Office Action Summary	Application No. 10/596,573	Applicant(s) HE ET AL.	
	Examiner VONGSAVANH SENG DARA	Art Unit 2826

DETAILED ACTION

FIG. 1

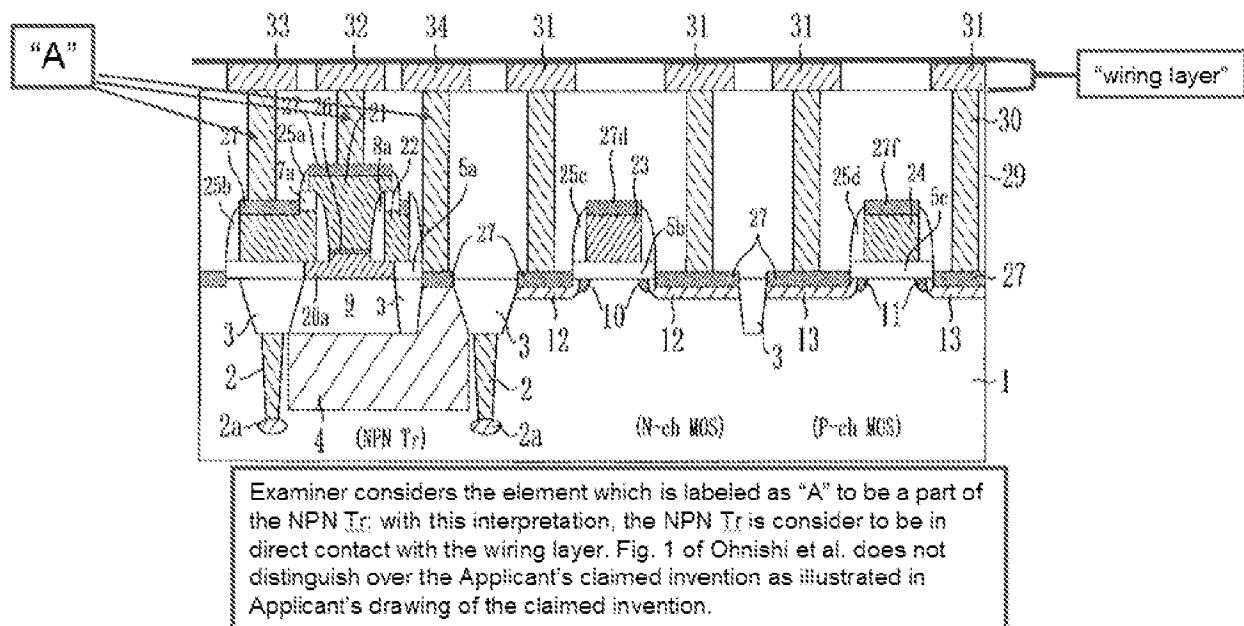
Claims 1, 2, 6, 7, 9, 10, 12 are rejected under 35 U.S.C. 102(b) as being anticipated by Ohnishi et al. (6399993).

Regarding claims 1 and 12, fig. 1 of Ohnishi et al. discloses an integrated circuit structure comprising:

- a substrate 1;
- a plurality of different height devices (three total: (1) NPN Tr, (2) N-ch MOS, and (3) P-ch MOS) positioned on said substrate 1;
- a passivating layer 29 positioned above said substrate 1 and between said devices;
- a wiring layer (examiner labeled as "wiring layer") above said passivating layer 1, wherein at least one of the tallest (NPN Tr) of said plurality of devices is in direct contact with said wiring layer and at least one of the shorter (N-ch MOS or P-ch MOS) of said plurality of devices is connected

to said wiring layer by a first contact 30 extending through said passivating layer 29.

NOTE: Examiner considers the element which is labeled as "A" to be a part of the NPN Tr; with this interpretation, the NPN Tr is consider to be in direct contact with the wiring layer. Fig. 1 of Ohnishi et al. does not distinguish over the Applicant's claimed invention as illustrated in Applicant's drawing of the claimed invention.

Regarding claim 2, with reference to 112 2nd rejection, fig 1 of Ohnishi et al. further discloses wherein said at least one of the tallest of said plurality of devices is in direct contact with a first second contact (examiner interpret this be the contact "A" which the examiner labeled in fig. 1 of Ohnishi et al. above) in said wiring layer.

Regarding claim 6, fig 1 of Ohnishi et al. further discloses wherein said wiring layer further comprises wiring (31, 32, 33, 34) within said wiring layer.

Regarding claim 7, fig 1 of Ohnishi et al. further discloses said first contact 30 is connected to said wiring 31 in said wiring layer.

Regarding claim 9, fig 1 of Ohnishi et al. further discloses wherein said at least one of the tallest of said plurality of devices (NPN Tr) comprises a different type of device (NPN Tr) than said at least one of the shorter (MOSFETs) of said plurality of devices.

Regarding 10, with reference to 112 2nd rejection, fig 1 of Ohnishi et al. further disclose wherein the top of said at least one of the tallest (which the examiner interpret to be the top of element "A" as labeled in fig. 1) of said plurality of devices is substantially coplanar (the top of "A" is coplanar) with the top of said passivating layer 29.

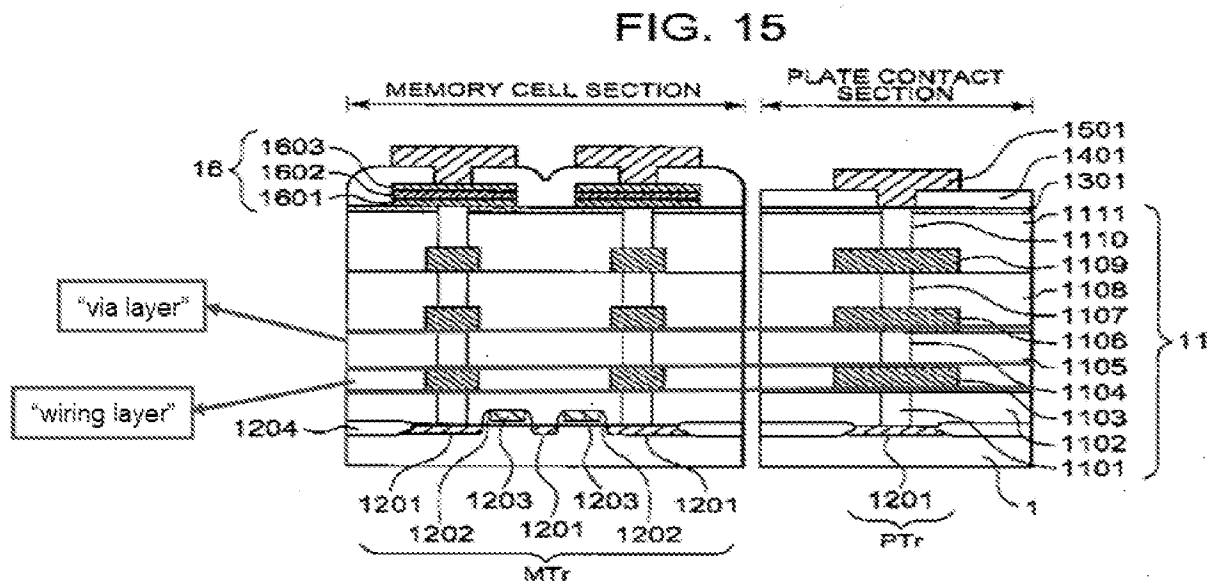
Claims 3, 4, 5, and 8 are rejected under 35 U.S.C. 103(a) as being unpatentable over Ohnishi et al. (6399993) in view of Mori (2004/0021222).

However, fig. 15 of Mori disclose a discloses an integrated circuit structure comprising: a substrate 1; a plurality of devices positioned on said substrate 1; a passivating layer 1102 positioned above said substrate 1 and between said devices; a wiring layer (examiner labeled as "wiring layer") above said passivating layer 1.

Fig. 1 of Mori further discloses comprising a via layer (examiner labeled as "via layer") above said wiring layer, wherein said second contact 1104 is directly connected to said via layer.

Regarding claim 4, with reference to 112 2nd rejection, fig. 15 of Mori further disclose wherein said second contact extends through said via layer to said wiring layer.

Regarding claim 5, with reference to 112 2nd rejection, fig. 15 of Mori further disclose wherein said second contact is positioned within said via layer.

Regarding claim 8, with reference to 112 2nd rejection, fig. 15 of Mori further discloses where said at least one of the tallest of said plurality of devices is in direct contact with a wire in said wiring layer (made of aluminum- see par [0074]) and said
